ORDINANCE NO. 02-10-7

An ordinance approving and authorizing the execution of Change Order No One (1) for Parish Project No. P980701 Willowdale Drainage Pump Station to increase the size of the new triplex station from 360 CFS to 525 CFS, and increase the amount of the contract by \$473,714.00 in order to handle the entire West Bank Master Drainage Plan flow of 524 CFS with new pumps.

ATTACHMENT 1 - DESCRIPTION OF CHANGES

BASE BID FOR PARISH PROJECT NO. P980TD1; WILLOWDALE DRAINAGE PUMP STATION

WILLOWDALE DRAINAGE P.S. SUMP DESIGN

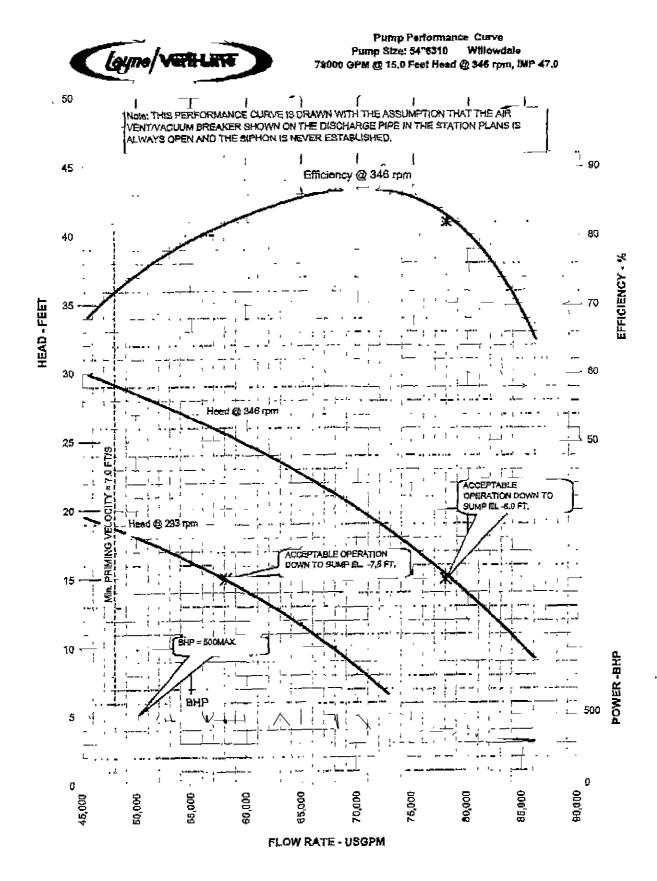
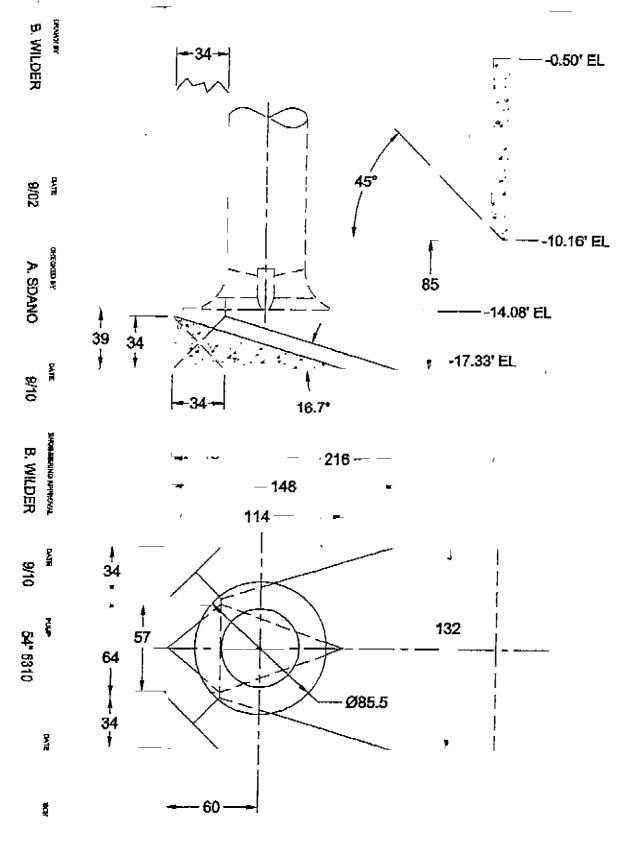
Per your convergation with Arnie Sdano, Director of Engineering, you discussed three options to reduce sub-surface vortices. Attached with this letter is the option you settled on, as shown in drawing T-063330. The dimensions in the drawing are based on the anticipated bell diameter size of 85.5°.

We confirm that the measures you are undertaking via the addition of fillets and splitters will reduce the probability of vortices to the point where Layne/Verti-Line will guarantee the performance of the pumps in the modified sump when operating at the rated flow and speed while at the "pump off" intake elevation of -6.0 feet. We also confirm that the pumps can be operated at a reduced pump speed of 293 RPM down to an intake elevation of -7.5 feet in order to draw down the suction canal in advance of an approaching storm. These guarantees are based on the pump station drawing (G-3) supplied to Layne/Verti-Line showing the vent/vacuum breaker, which we assume, is always open and that the siphon is never established.
